A G E N D A
CANBY PLANNING COMMISSION
REGULAR MEETING

City Council Chambers
Monday, February 13, 1995
7:30 p.m.

**REVISED
- STAFF REPORT -**

SITE PLAN
 $\frac{1}{30}'' = 1'-0''$

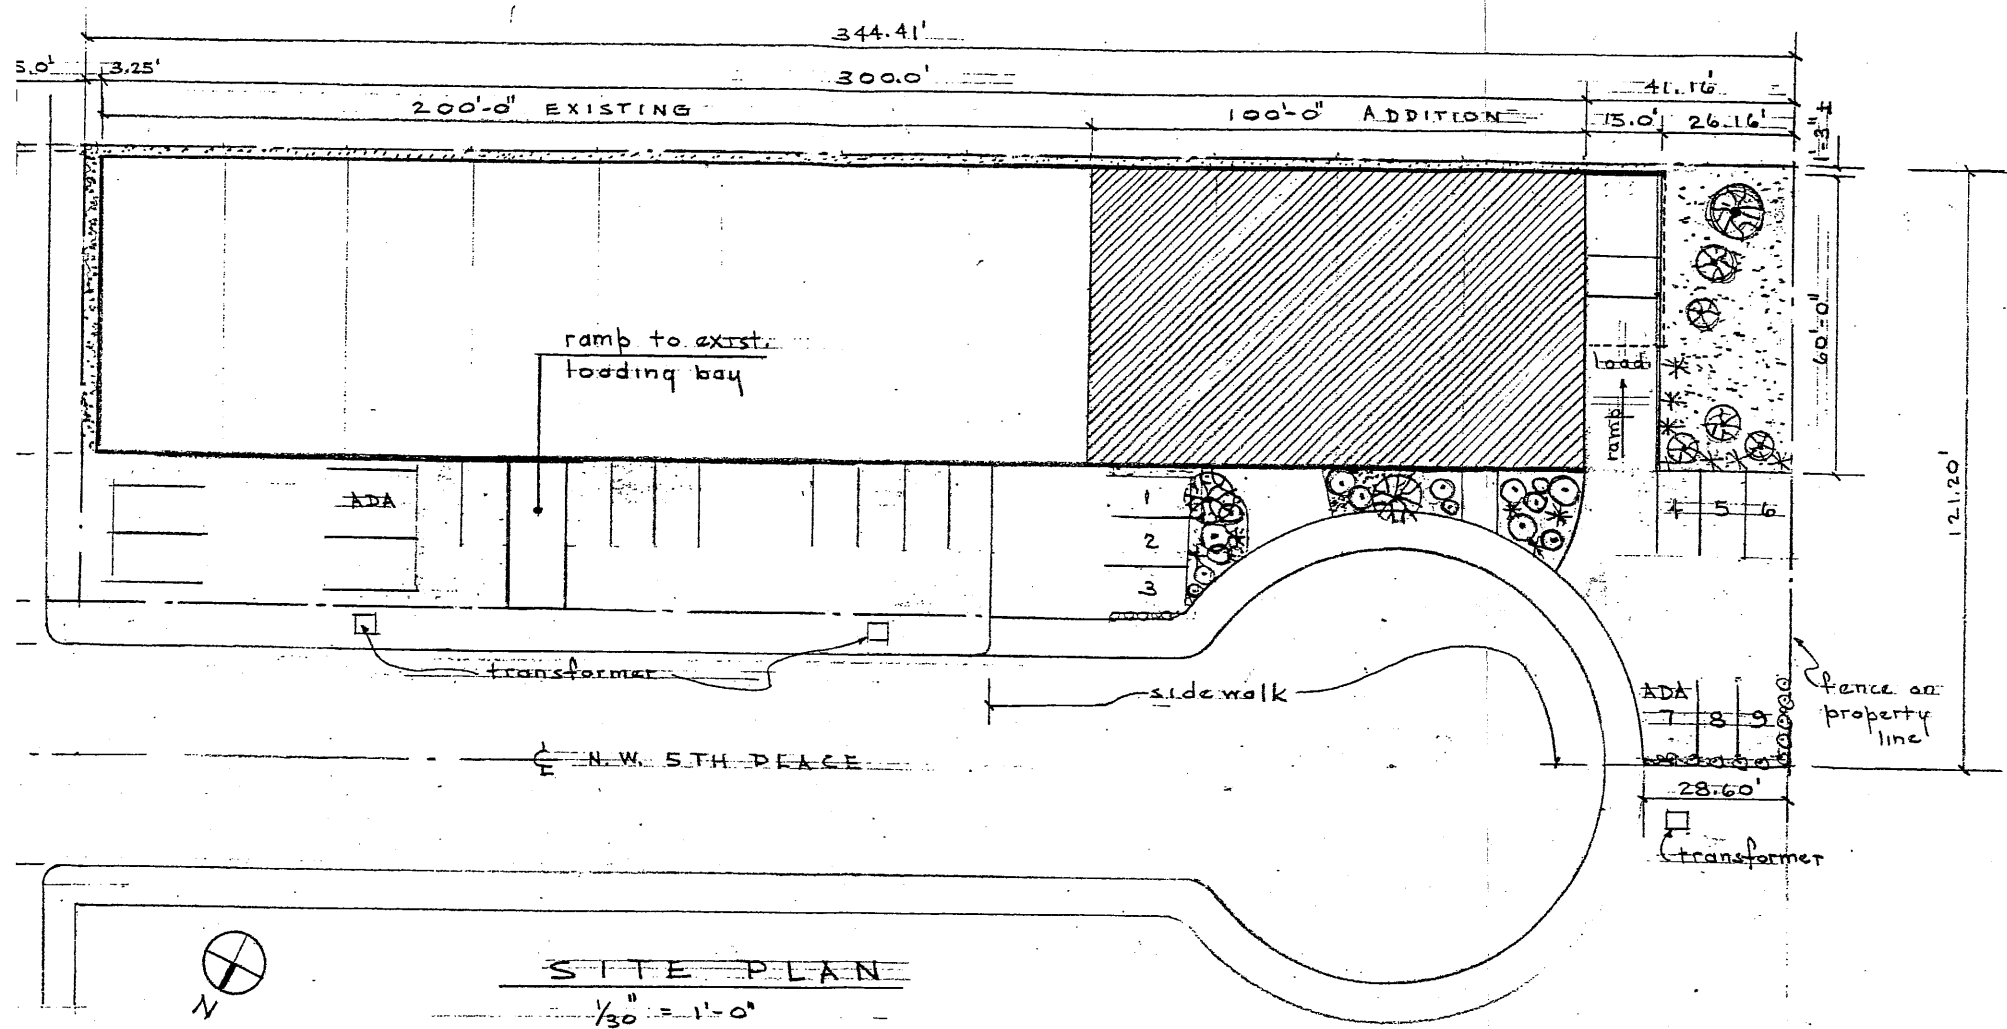
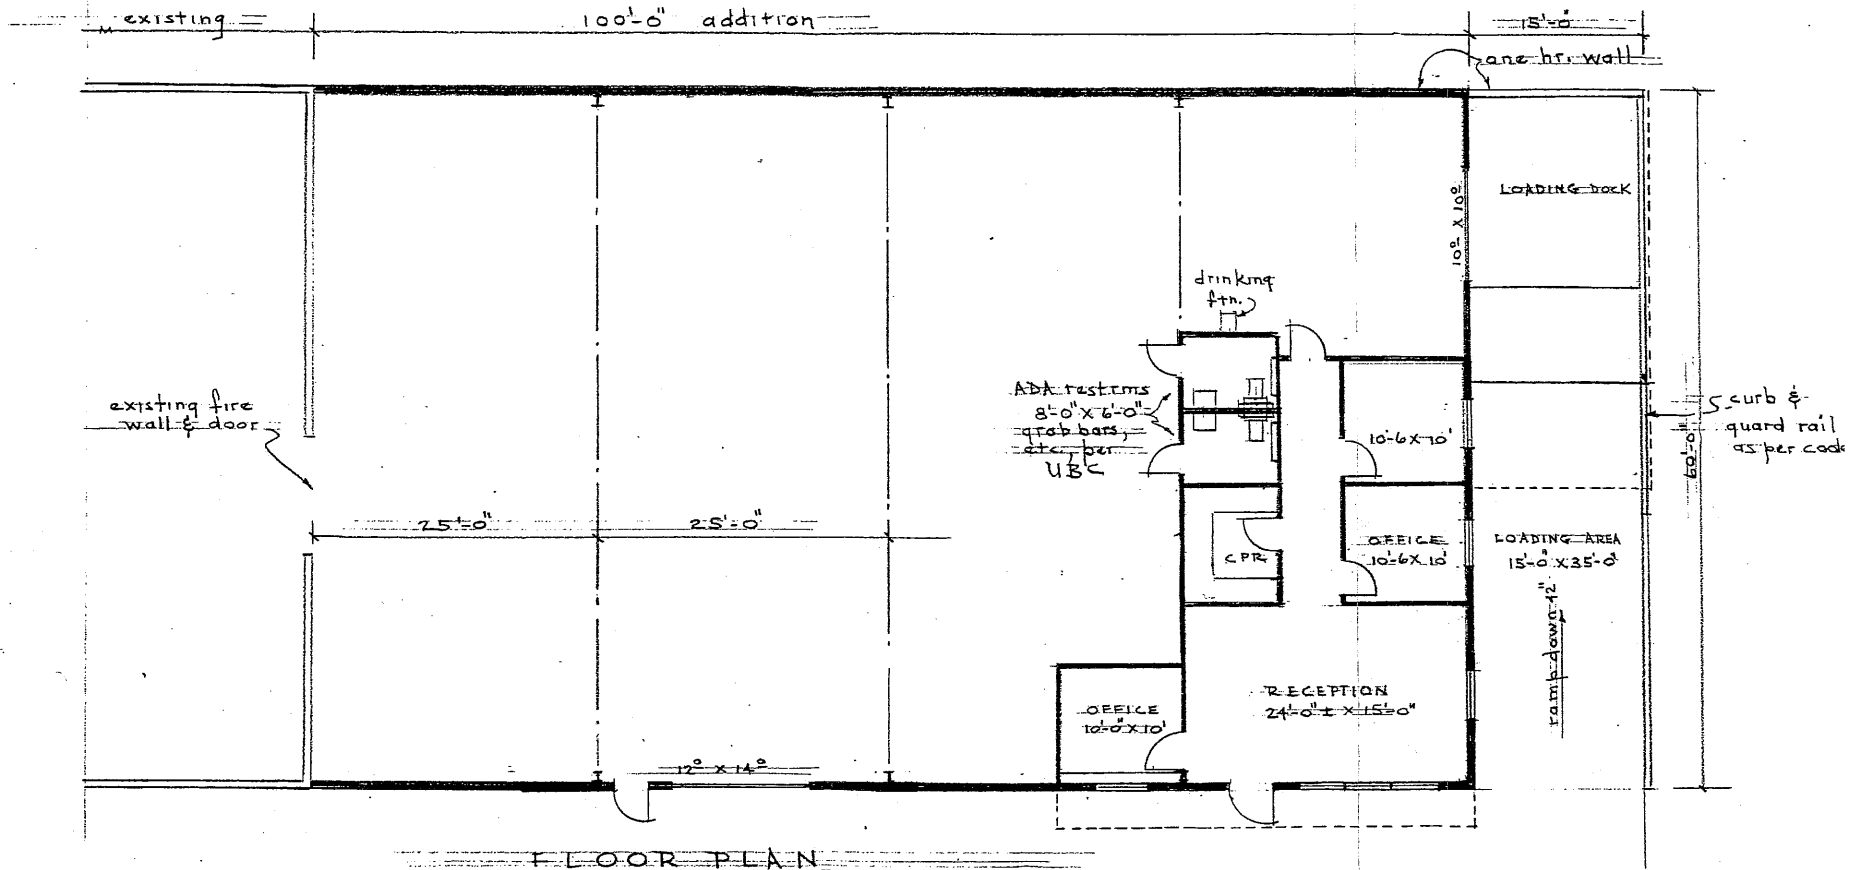
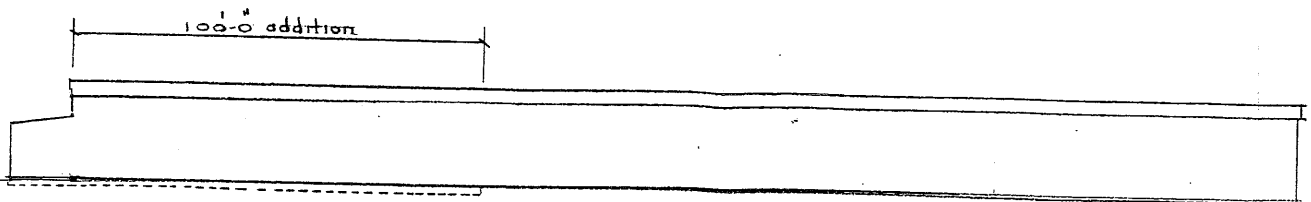
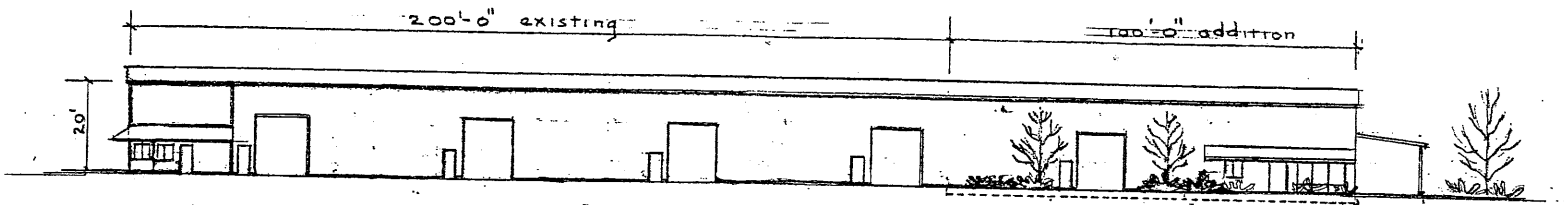
A revision in the original landscape plan is expected to be submitted to the City this week. The revision consists of a minor redesign of the western 3 parking spaces and provision of the required loading space. **THE REVISION CONCENTRATES ALL CHANGES TO HIS EXPANSION AREA.**

The minimum amount of landscaping required for the 11,300 square feet is about 1,700 square feet, or 15%. The total amount of landscaping appears to exceed this amount since it is proposed to provide landscaping ~~and reduction of existing parking bays on the adjacent lot area~~ **OF 1,916 SQUARE FEET, OR 17%.**

1. Storm water design and construction of the paved area of the property shall conform to the Canby Public Works Department standards.
2. A detailed construction landscape plan shall be submitted with the building permit. The detailed landscape plan shall show: the number of plants, plant spacing/location of planting, the type of plants, the schedule of planting, and irrigation plans.
3. The landscaping shall be planted at a spacing that matches or exceeds (in density) the standards for plantings provided by the Oregon Department of Transportation. Bark mulch and similar material shall consist of not more than 5% of the total landscape area after the 3-year period. River rock, or similar landscape material, shall consist of not more than 5% of the total landscape area.
4. The tax lots shall be combined or a parking agreement recorded with the County Registrar of Deeds.

RE : DR95-05 / SHARPCOR, INC./CANBY APTS.

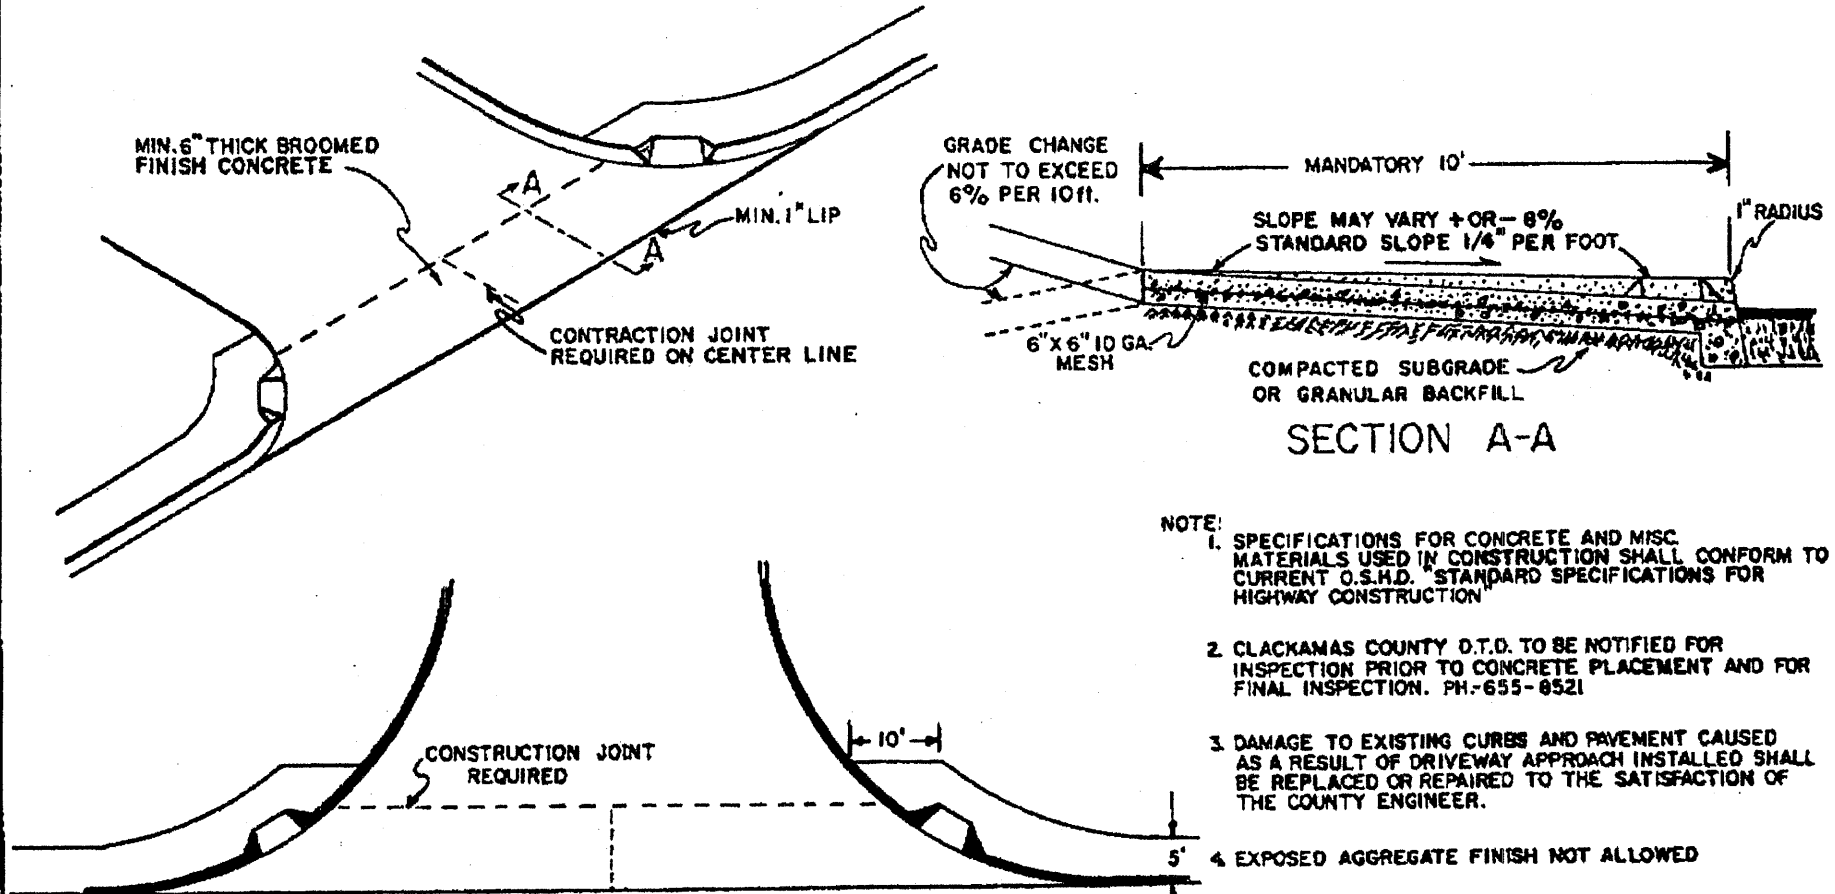
1. Township road is a County maintained road and is classified as a minor arterial. The proposed driveway entrance and small amount of frontage shall be improved to County standards. Refer to DRG-C-100 and DRG-D-300 attached. The curb shall align with established curb on Township Road but shall not be less than 18 feet off center. This will enable two twelve foot travel lanes and two six foot bike lanes.

2. Pine Street is a "Public Road" that the County does not maintain. We are in agreement that access should not be allowed. No additional improvements to Pine Street should be required. However, as an adjoining property owner there may be some responsibility for assisting with maintenance. There appears to be a previous twenty foot wide street dedication from the subject property along Pine Street. This must be confirmed. If in fact this has not been completed it must be completed with this application.
